Interactive comment on “Spatial distribution of oxygen-18 and deuterium in stream waters across the Japanese archipelago” by M. Katsuyama et al.

Received and published: 4 December 2014

Fig. 2. Replaced Figure 3

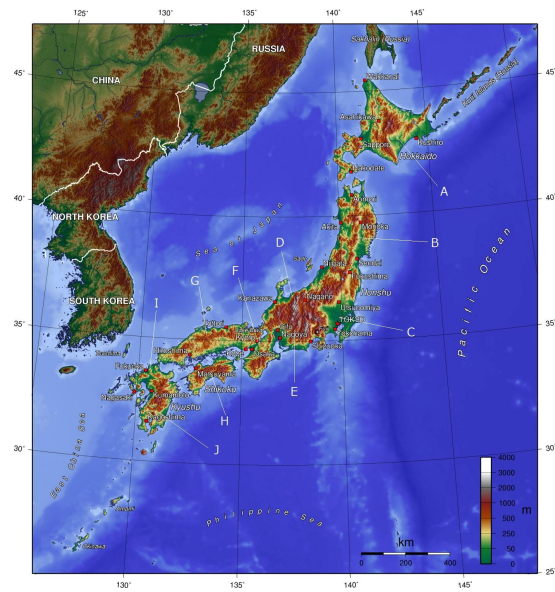
Reviewer's comment 1. Given the important influence of the geographical parameters (e.g., ELV) on the surface water isotope distribution, it would be better to show a topographic map that helps reader to understand your analysis. To this end, you may add DEM information in your Figure 3. **Authors' Reply** Figure 3 is changed to the topographic map of Japan.

Fig. 3. Replaced Figure 4

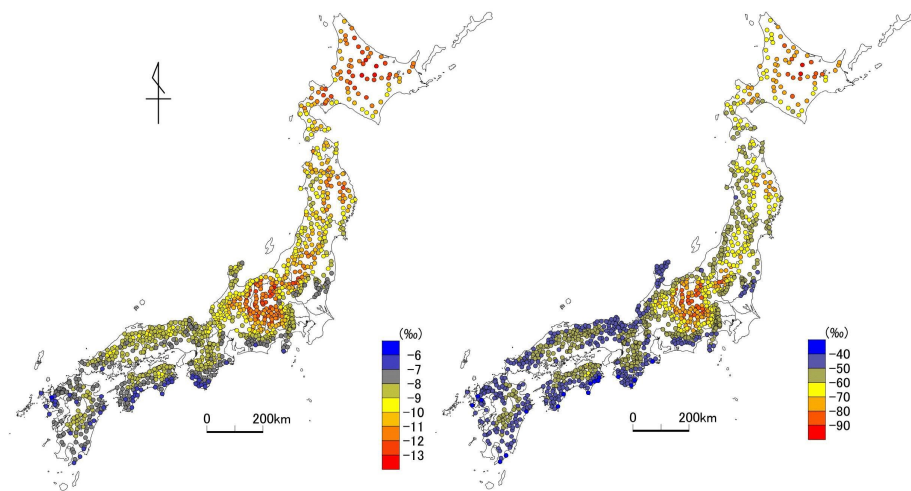
Reviewer's comment 2. For your interpolated isotope maps, they are not highly visualized based on contour maps, I would recommend instead some color-shaded maps.

Authors' Reply Another reviewer also pointed out about this. The Figures 4 and 5 are replaced to colour-coding maps according to observed $\delta^{18}\text{O}$ and $\delta^2\text{H}$, as well as d-excess value. These maps clearly show the spatial distribution of the stream water isotope signature across Japan.

Fig. 5. Replaced Figure 6

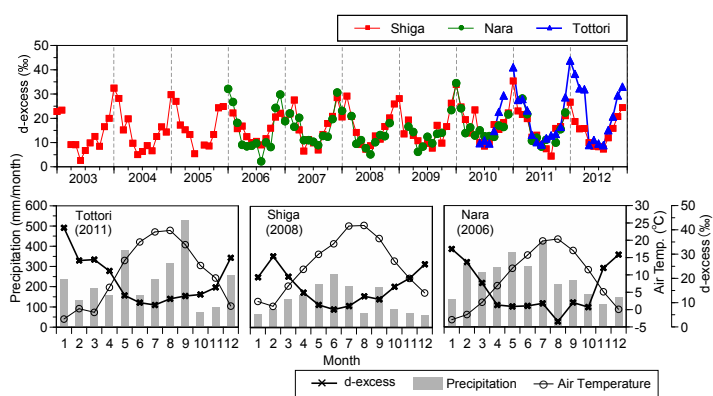
Reviewer's comment 3. In section 3.3, the authors should briefly explain the reason why the d-values of precipitation have such a seasonal pattern. If moisture sources are a dominant control on the seasonal variation in d values of precipitation and stream water, so the spatial difference in d values may be a reflective of the seasonal balance of precipitation input. As the authors pointed out, late snowmelt may affect the difference in d values between river water and precipitation on the on the Sea of Japan side. But this may be not the whole truth. The groundwater and surface flow recharged from winter precipitation may also contribute to this difference?

source regime of Japan, which control the seasonality of the d-values of precipitation, and other studies also explained the same mechanism. One of the example, we referred Araguás-Araguás et al. (1998) in Section 3.3. As for seasonality, we revised Figure 6 to show the long-term variation of monthly d-excess in precipitation in addition to previous panels. We are afraid that the reviewer somewhat misunderstand about what we pointed out: we pointed out that late snowmelt recharges the groundwater which is the source of stream flow, and/or directly recharges the stream at the Sea of Japan side. This cause the difference of the relationship between precipitation and streamwater d-excess in the Sea of Japan side and in the Pacific Ocean side.
